Model: GR-C1	Date: 21-Mar-12	No.: RD117001b
--------------	-----------------	----------------

Subject: Firmware Release Note: (Java VM v10 for eDC)		Prepared by: H. Tamaki	
From: 1st Tech Service Sect., MFP/Printer Tech Service Dept.			
Classification:	<input type="checkbox"/> Troubleshooting	<input type="checkbox"/> Part information	<input type="checkbox"/> Action required
	<input type="checkbox"/> Mechanical	<input type="checkbox"/> Electrical	<input type="checkbox"/> Service manual revision
	<input type="checkbox"/> Paper path	<input type="checkbox"/> Transmit/receive	<input type="checkbox"/> Retrofit information
	<input type="checkbox"/> Product Safety	<input checked="" type="checkbox"/> Other (Firmware)	<input checked="" type="checkbox"/> Tier 2

This RTB has been issued to announce the firmware release information for the **Java VM v10 for eDC**.

**Change:** An index in the illustration was added.

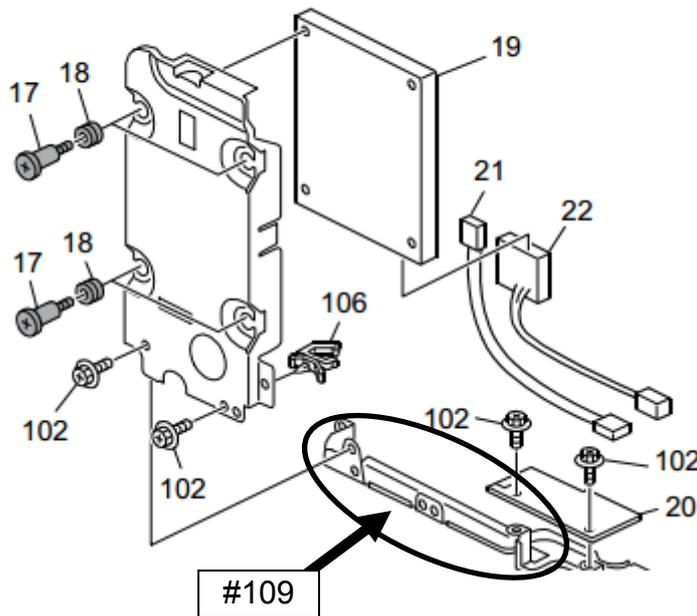
**See the following diagram for the corrected illustration.**

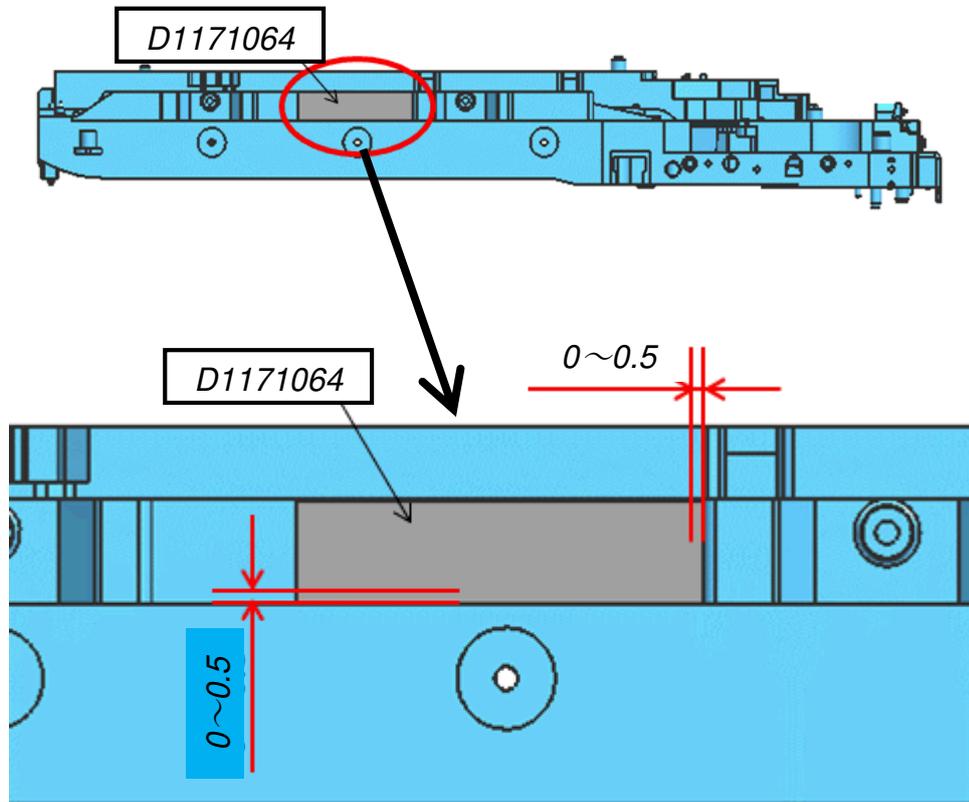
- Four ribs were added to the exit cover, in order to prevent the laser unit from moving.
- A seal was attached to the mainframe, in order to prevent noise generated from the additional ribs.

**In the field:**  
**Replace the exit cover and attach the seal to the machine, as shown above.**

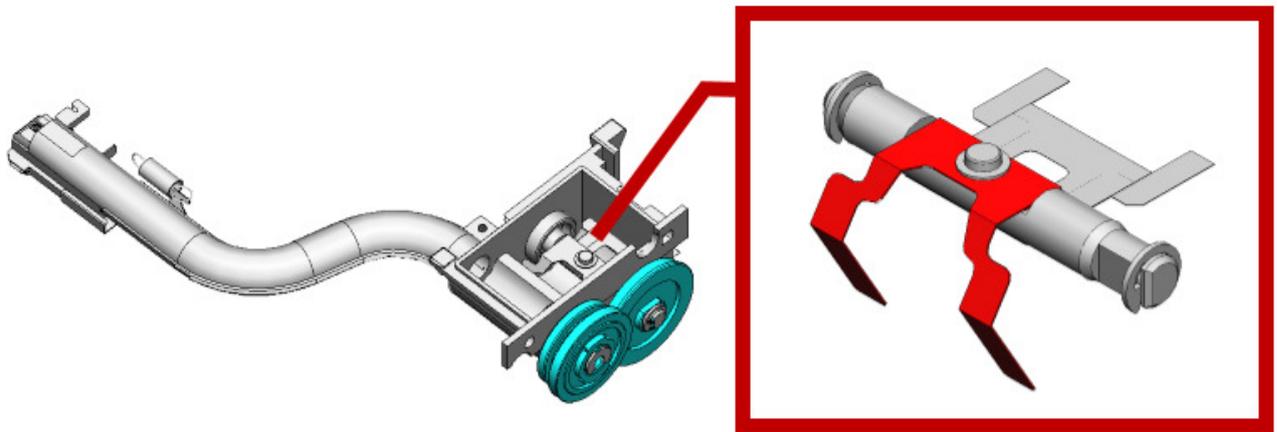
- For the GR-C2, the toner hopper was modified as shown below. The Mylar highlighted in red was added to improve the toner agitation power.
- This change reduces the occurrence of symptoms that develop over time.

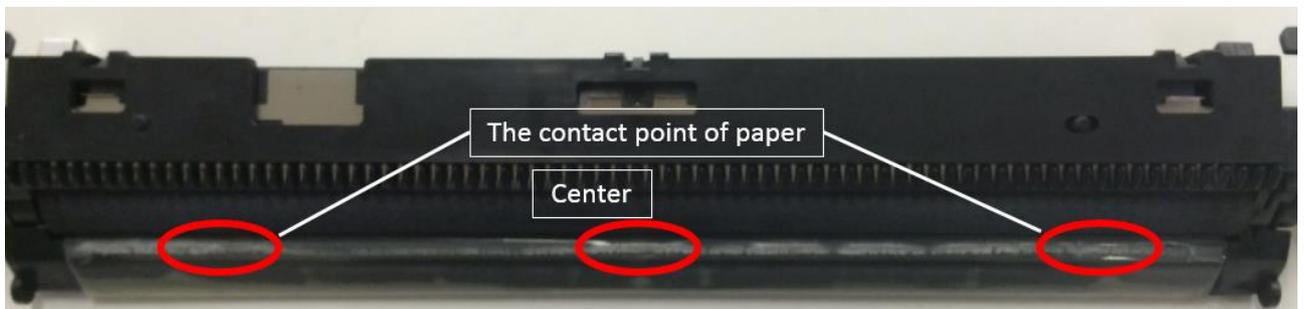
The molded part of the Transfer/Separation unit (with the mylar attached) has three cutouts.

If a customer uses a paper with rough edges, the mylar is gradually damaged at the center and at the contact points of the paper side edges (shown in the pictures), and then the mylar peels off from the molded part.

**Downloading Stamp Data**

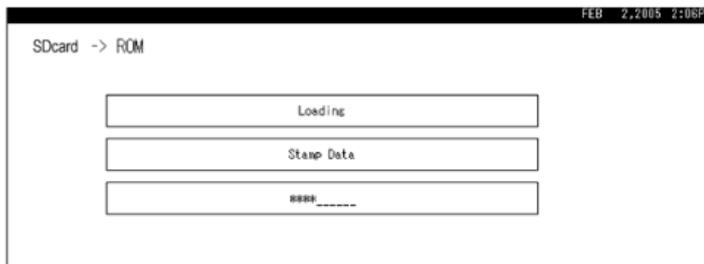
**Delete** the following instructions on “Downloading Stamp Data.”  
 This section is unnecessary because GR-C1 is not equipped with the stamp function.

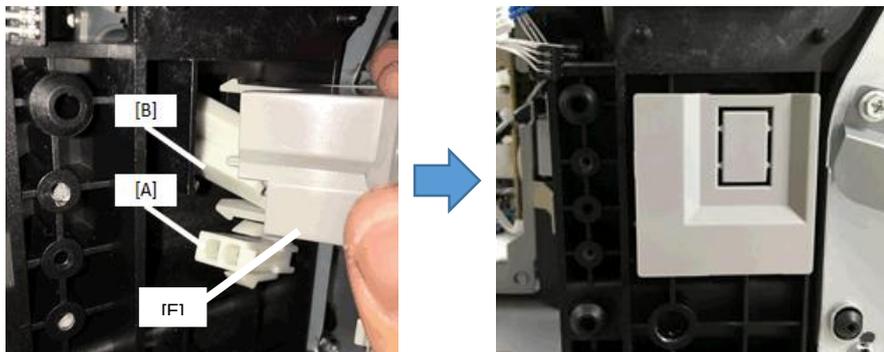
- Remove the cover [E], and then pull out the junction harness connectors [A] and [B].
- Store the connector [A] in the open space shown below.

- Store the connector [B] into the cover [E], and then attach the cover [E].

**★ Important**

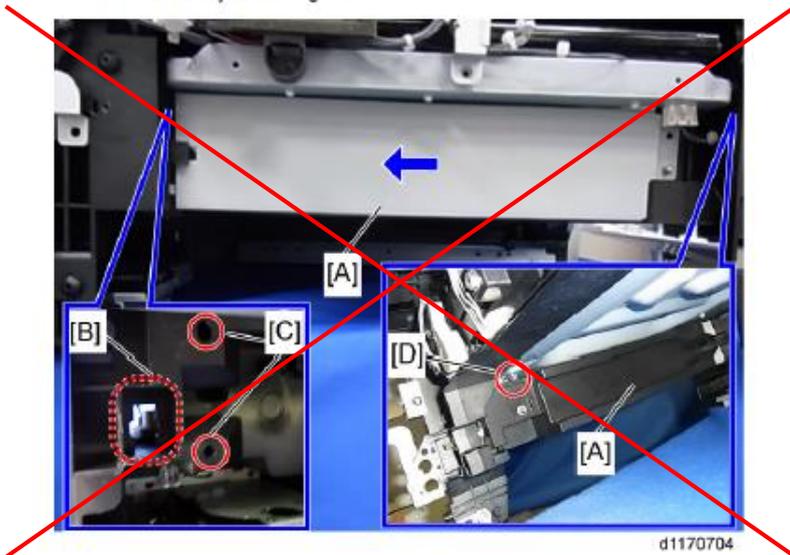
- ~~• Never press the main frame from above when the left stay [A] is removed. Otherwise, the mainframe may be damaged.~~

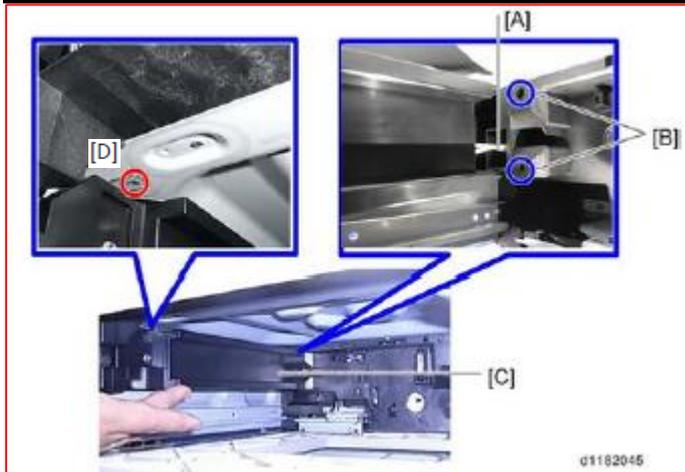
7. Pass the heater harness through the hole ~~[B]~~ [A]
8. Insert the spurs of the heater into the holes ~~[C]~~ [B], and then install the tray heater ~~[A]~~ [C] (  [D] x 1).
